**JAMES THOMAS BARNES SUBDIVISION,**  
**RESUBDIVISION OF**

APPLICATION NUMBER 17 DATE November 1, 2007

REQUEST Subdivision

# DETAIL SITE PLAN

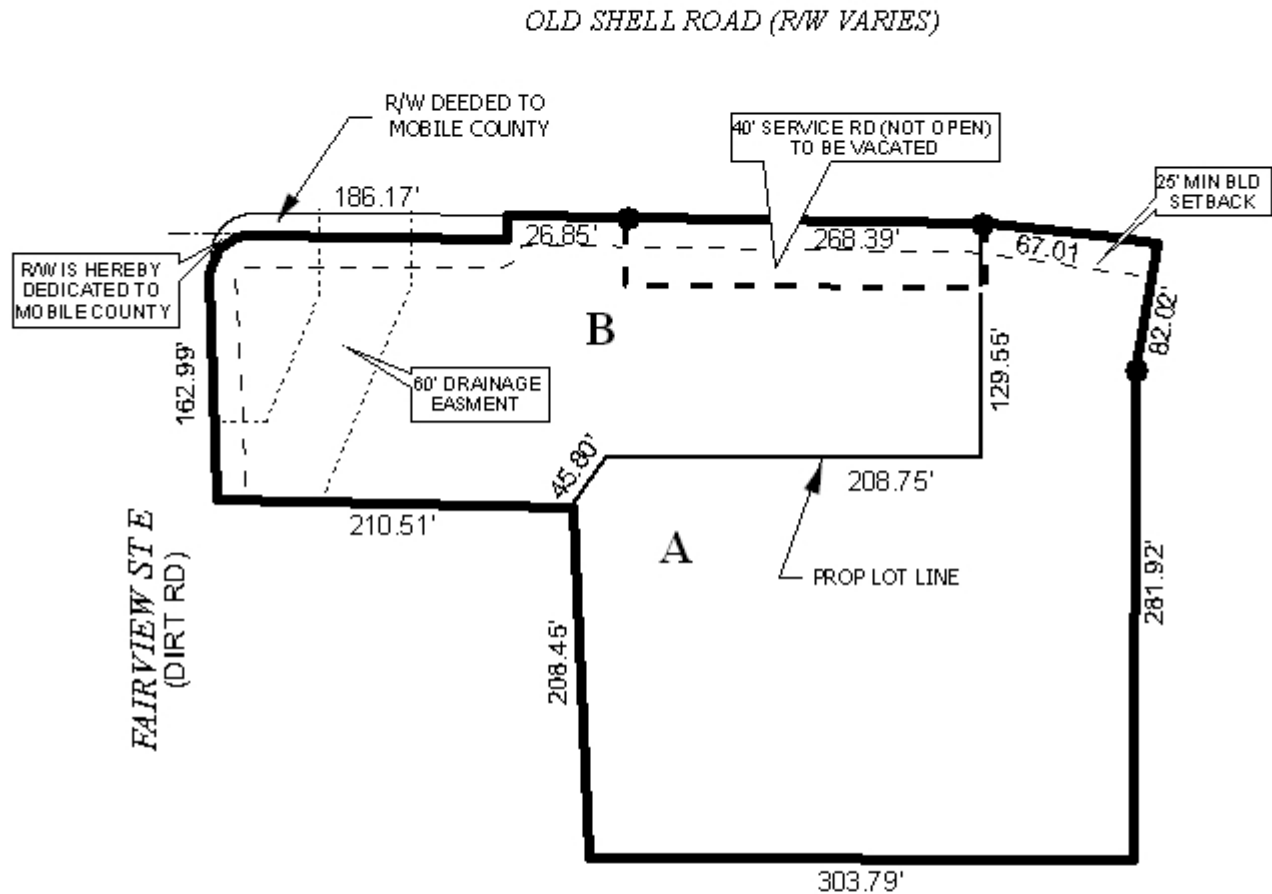
The site fronts Old Shell Road, a planned major street, requiring a 100' right-of-way. The recording of the original James Thomas Barnes Subdivision in 2005 dedicated sufficient right-of-way to meet the required 50' from centerline along the South side of Old Shell Road and a radius at the corner of Old Shell Road and Fairview Street East. Fairview Street East currently has right-of-way from centerline along the site in excess of the required 25' from centerline. The plat indicates an existing 40' unopened service road along a portion of the Old Shell Road frontage is to be vacated and incorporated into the site. Therefore, vacation of the service road should be required prior to the signing of the final plat.

The plat includes a note limiting Lot A to one curb cut, and Lot B to two curb cuts to Old Shell Road, with the size, location, and design of all curb cuts to be approved by County Engineering. This should also be required on the final plat with the addition of the curb cuts conforming to AASHTO standards. A note on the plat states that Lot B is denied access to Fairview Street East until it is improved to County standards; this should also be required on the final plat but expanded to require curb cut size, location, and design to be approved by County Engineering.

The 25' minimum building setback lines along Old Shell Road and Fairview Street East are indicated on the plat and should also be illustrated on the final plat. Additionally, the lot sizes in square feet are labeled on the plat and should also be labeled on the final plat, or a table depicting the same information should be provided.

The plat includes a note stating that any lots which are developed commercially and adjoin residentially developed property must provide a buffer, in compliance with Section V.A.7. of the Subdivision Regulations. This note should also be required on the final plat.

The site is in the unincorporated part of Mobile County; nevertheless, development should be designed to comply with the stormwater detention and drainage facilities of the City of Mobile stormwater and flood control ordinances. Submission of certification from a licensed engineer certifying that the design complies with the stormwater detention and drainage facilities of the City of Mobile stormwater and flood control ordinances prior to the issuance of any permits should be required. Certification should be submitted to the Planning Section of Urban Development and County Engineering. The plat includes a note addressing this issue and should also be required on the final plat.

- 1) vacation of the 40' service road along Old Shell Road prior to the signing of the final plat;
- 2) placement of a note on the final plat stating that Lot A is limited to one curb cut to Old Shell Road, with its size, location, and design to be approved by Mobile County Engineering and conform to AASHTO standards;

- 3) placement of a note on the final plat stating that Lot B is limited to two curb cuts to Old Shell Road, with the size, location and design of all curb cuts to be approved by Mobile County Engineering and conform to AASHTO standards;

- 4) placement of a note on the final plat stating that Lot B is denied access to Fairview Street East until it is improved to County standards. Upon improvement to county standards, Lot B is limited to one curb cut to Fairview Road East, with the size, location, and design to be approved by Mobile County Engineering;

- 5) illustration of the 25' minimum building setback line along Old Shell Road and Fairview Street East;
- 6) labeling of each lot with its size in square feet, or the provision of a table on the plat depicting the same information;

- 7) placement of a note on the Final Plat stating that any lots which are developed commercially and adjoin residentially developed property must provide a buffer, in compliance with Section V.A.7. of the Subdivision Regulations; and

- 8) placement of a note on the plat stating that the development will be designed to comply with the storm water detention and drainage facility requirements of the City of Mobile storm water and flood control ordinances, and requiring submission of certification from a licensed engineer certifying that the design complies with the storm water detention and drainage facility requirements of the City of Mobile storm water and flood control ordinances prior to the issuance of any permits. Certification is to be submitted to the Planning Section of Urban Development and County Engineering.
